Access Compliance Report

Public Rights-of-Way

(Curb Ramps)

Intersection ID: 8529	Main Street: LASALLE_ST	Cross Street: BROWNSTONE_ST	Location: NW
ADA ID: 2011B76A8DE6	Ramp Type: Perp	Initial Pass/Fail: Fail	Overall Compliance: No
Codes/Mitigation Info/Possible Solution		Field Measurements/Component Compliance	
Severity Score: 18.75

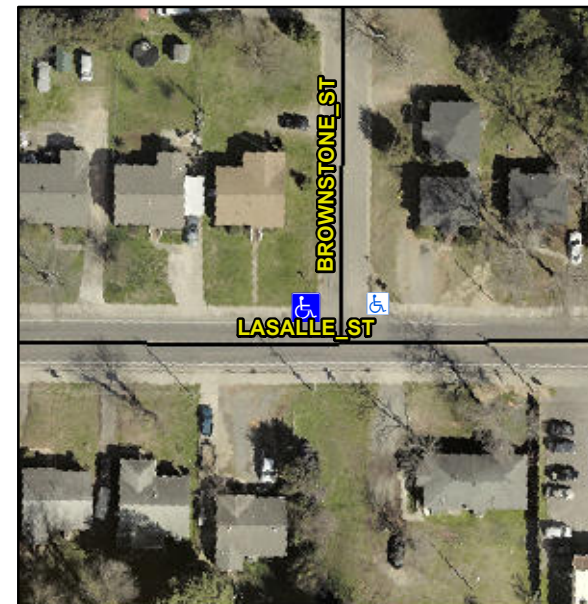
Not Found, R304.5.1, R304.5.3

Compliance	Description	Data	Compliance	Description	Data
N/A	Ramp Length (in)	51.0	Yes	Ramp Slope (%)	6.2
No	Ramp Width (in)	33.0	No	Ramp XSlope (%)	3.5
N/A	Flare Type LT	N/A	N/A	Flare Type RT	N/A
N/A	Flare Slope LT (%)	N/A	N/A	Flare Slope RT (%)	N/A
N/A	Flare Traversable LT?	N/A	N/A	Flare Traversable RT?	N/A
N/A	Landing Length (in)	N/A	N/A	DWS Provided?	N/A
N/A	Landing Width (in)	N/A	N/A	DWS Contrast?	N/A
N/A	Landing Slope (%)	N/A	N/A	DWS Length (in)	N/A
N/A	Landing X Slope (%)	N/A	N/A	DWS Full Width?	N/A
N/A	Landing Curb? (Y/N)	N/A	N/A	DWS Offset (in)	N/A
N/A	Shared Landing?	N/A			
N/A	Gutter Ponding?	N/A	N/A	Gutter Slope (%)	N/A
N/A	Gutter Lip Ht (in)	1.0	N/A	Gutter X Slope (%)	N/A
N/A	Painted X Walk1?	No	N/A	Painted X Walk2?	N/A
	X Walk 1 Direction	To E		X Walk 2 Direction	N/A
N/A	X Walk 1 Width (in)	N/A	N/A	X Walk 2 Width (in)	N/A
	X Walk 1 Slope (%)	0.2		X Walk 2 Slope (%)	N/A
	X Walk 1 X Slope (%)	1.8		X Walk 2 X Slope (%)	N/A

Possible Solutions:

Remove & Replace Entire Ramp.
